Product Change Description

As the applicant of the below model, we **Amgoo Telecom Co., Ltd.** declares that the product mobile phone (Model: AM301), is the variant of the initial certified product mobile phone (Model: AM217, FCCID: UOSAM217) .

2) Circuit

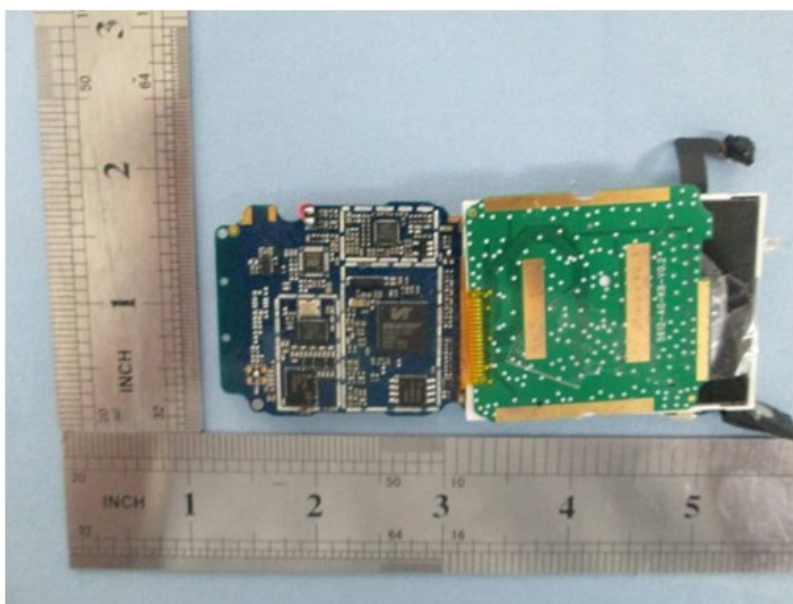
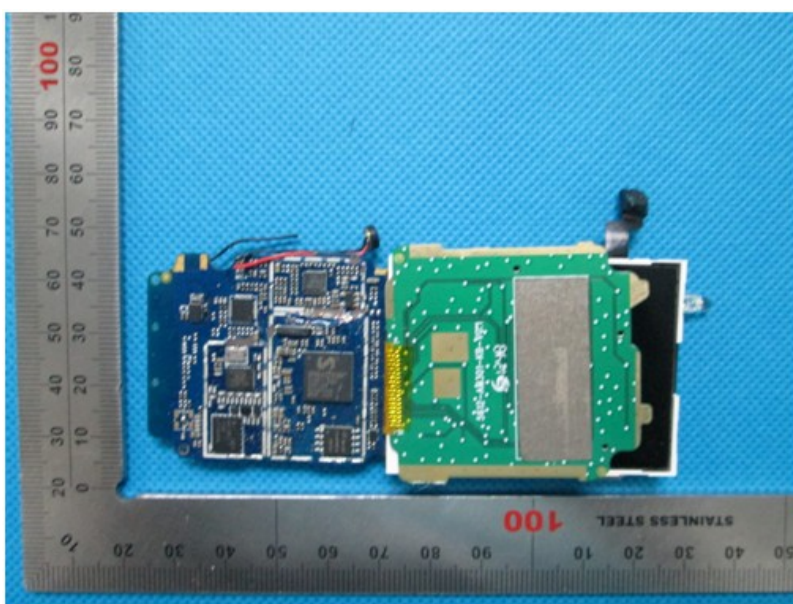
C: The complete keypad

The keypad was changed on appearance, circuit and layout
